20 Church St Fritchley
Belper DE56 2FQ

PROPOSED GROUND FLOOR PLAN

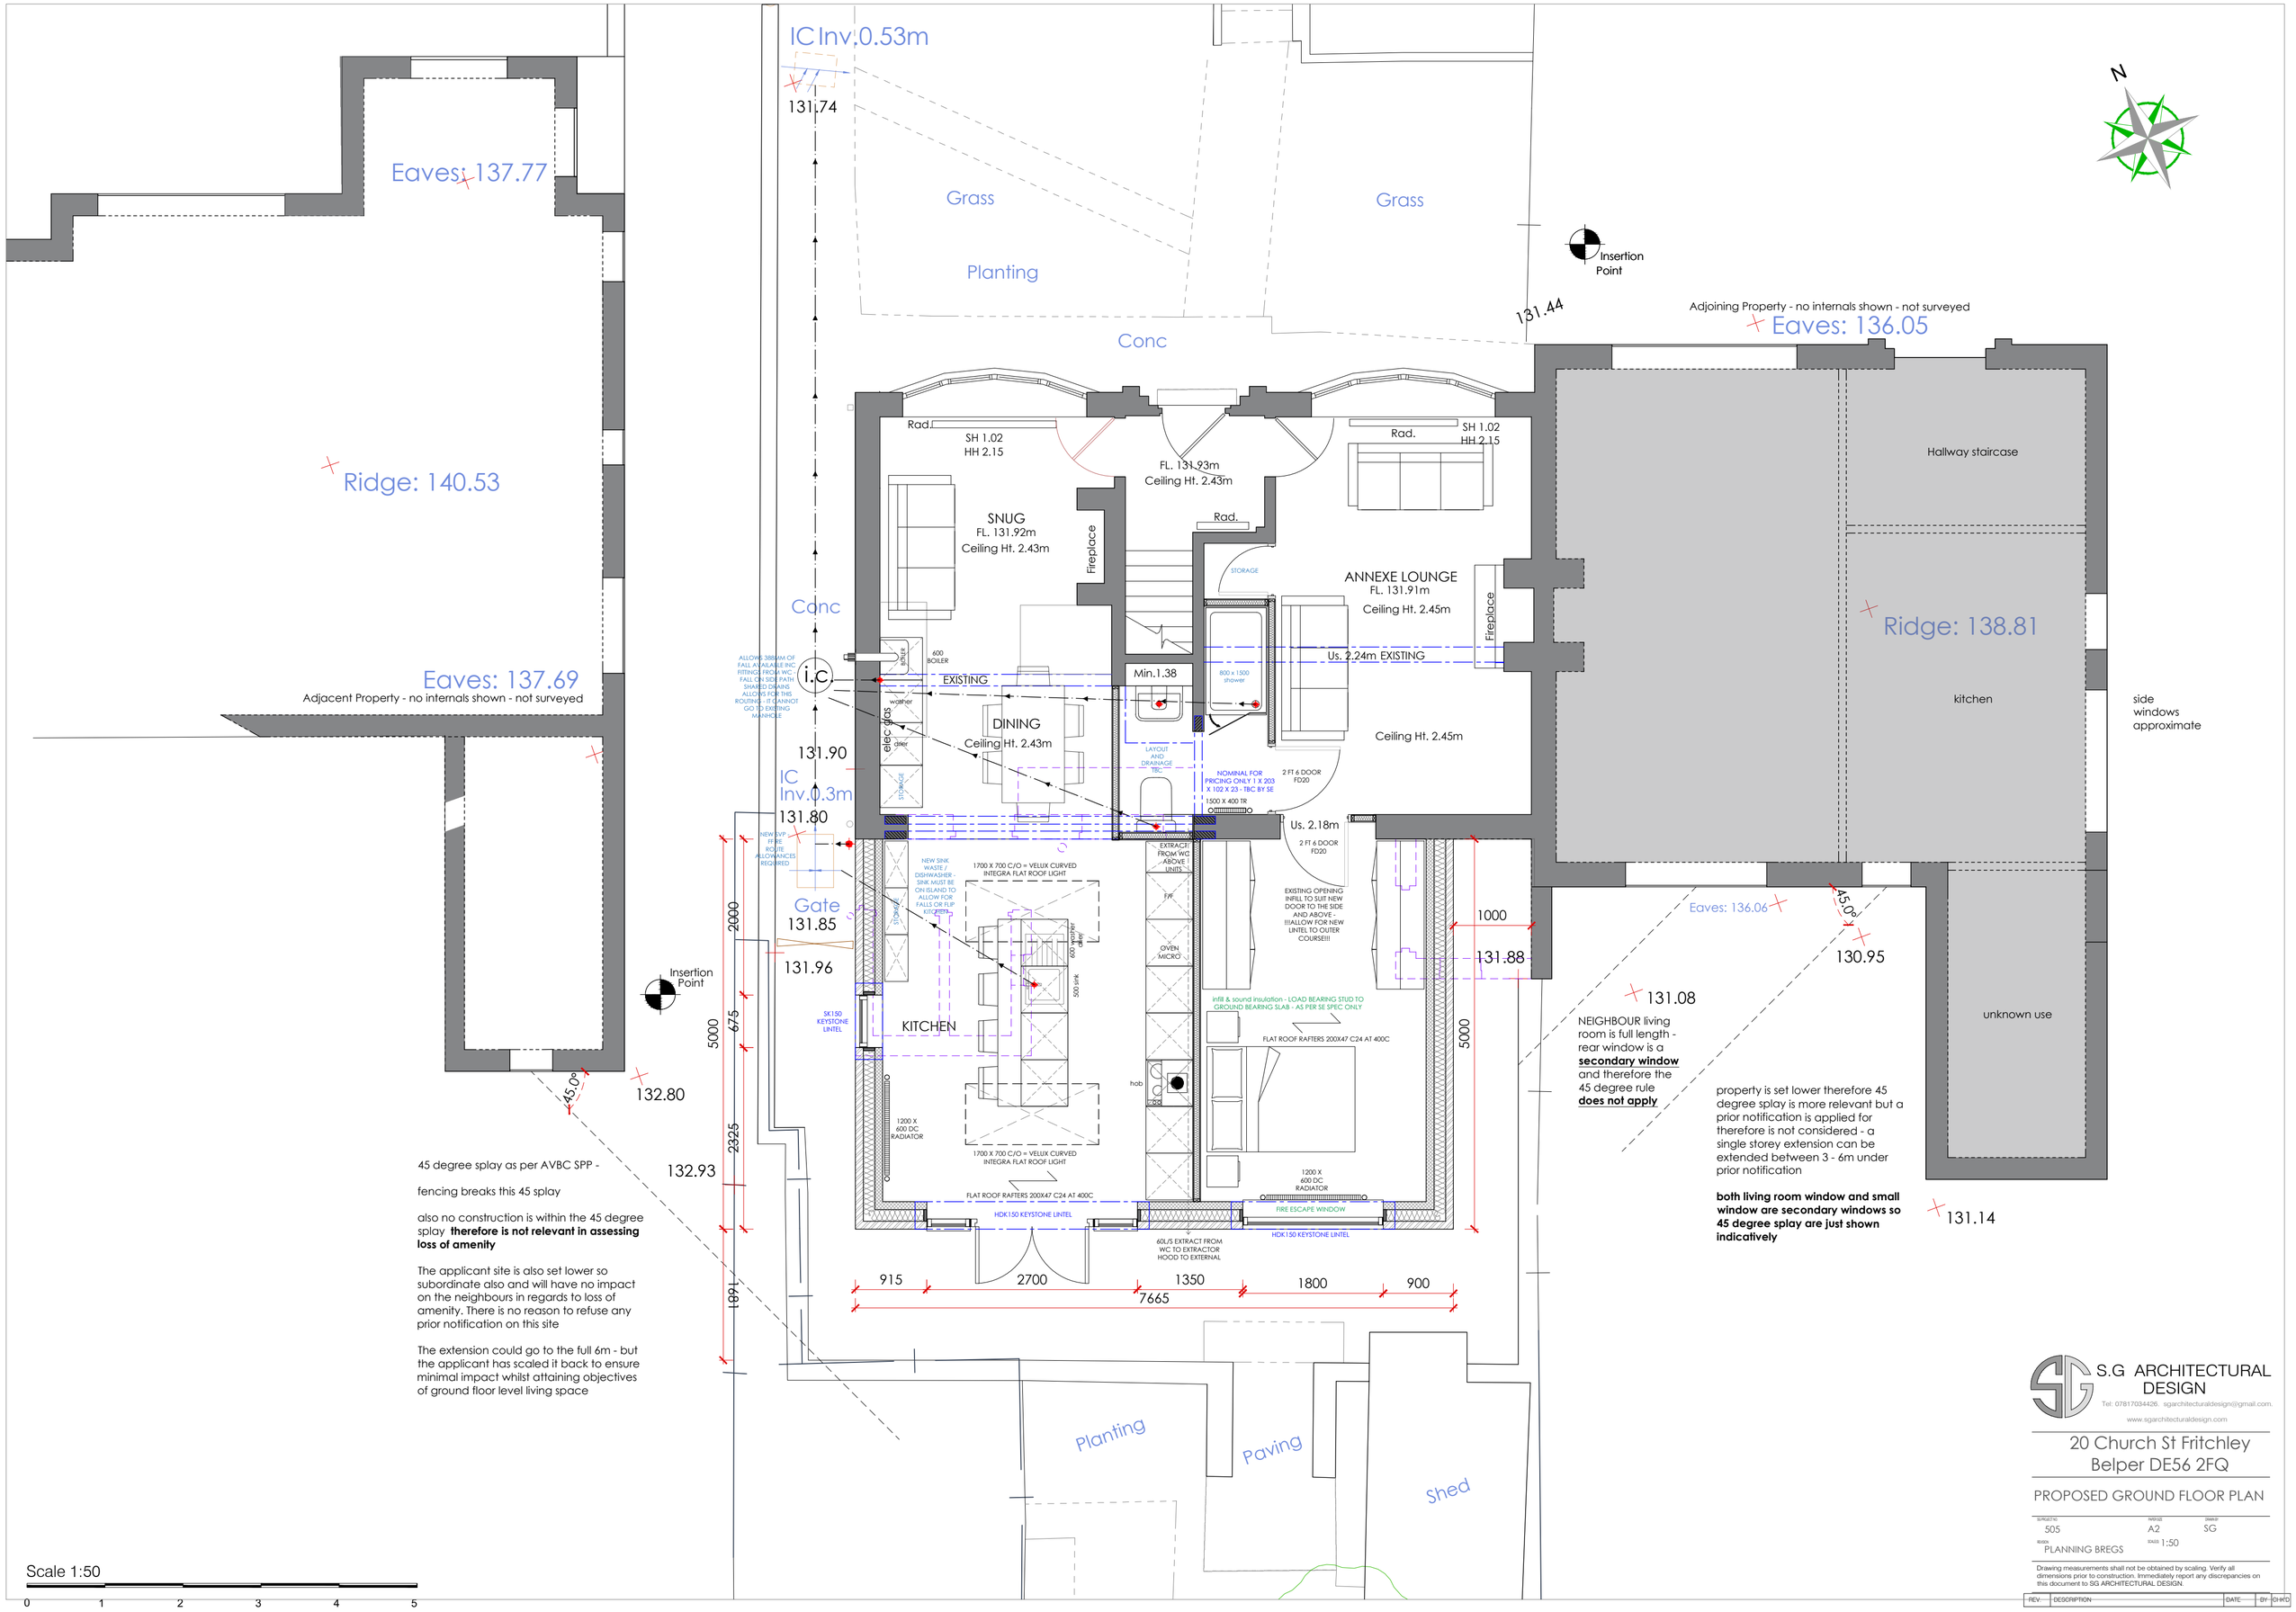
45 degree splay as per AVBC SPP -

fencing breaks this 45 splay

also no construction is within the 45 degree splay **therefore is not relevant in assessing loss of amenity**

The applicant site is also set lower so subordinate also and will have no impact on the neighbours in regards to loss of amenity. There is no reason to refuse any prior notification on this site

The extension could go to the full 6m - but the applicant has scaled it back to ensure minimal impact whilst attaining objectives of ground floor level living space
